Design Development Plans

Newport National West Course

Located on Wyatt Road and Mitchell's Lane
 Middletown, Rhode Island
 Assessor's Plat 124 Lot 29

DEPARTMENT OF ENVIRONMENTAL MANAGEMENT
 OFFICE OF WATER RESOURCES
 FRESHWATER WETLANDS PROGRAM
 APPROVED WITH CONDITIONS
 AS SPECIFIED IN THE LETTER OF APPROVAL
 DATED JAN 26, 2021 FILE # 20-0019
 NO CHANGES ALLOWED WITHOUT PRIOR APPROVAL
 APPROVED PLANS MUST BE AT CONSTRUCTION SITE

Detail Sheet-2

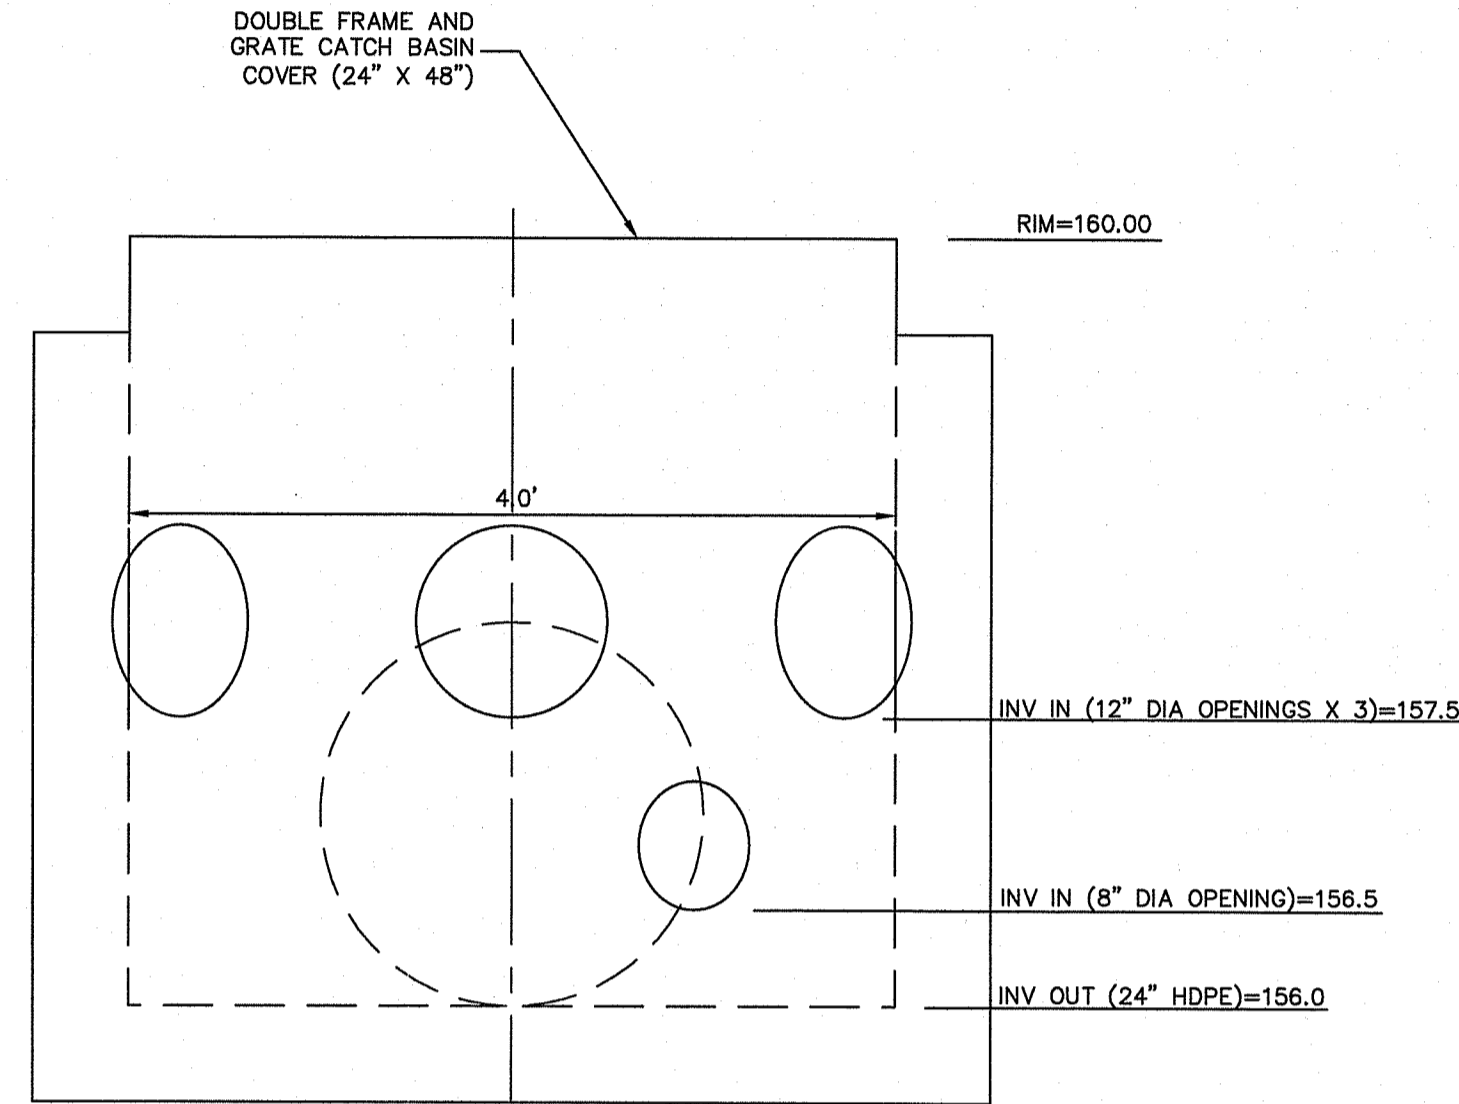
NOTE PER DEM:

With regards to Item No. 1 in the Flyover Vegetation Notes: sheep laurel is deleted and shall be replaced with a choice of highbush blueberry (*Vaccinium corymbosum*) and/or winterberry (*Ilex verticillata*), planted 5 to 6 feet on center, interspersed throughout the flyover areas with the inkberry (*Ilex glabra*) and sweet gale (*Myrica gale*).
Additionally, Item No. 2 has also been modified to limit trimming within flyovers to once per year between September 1st and March 31st, to minimize disturbance to resident wildlife.
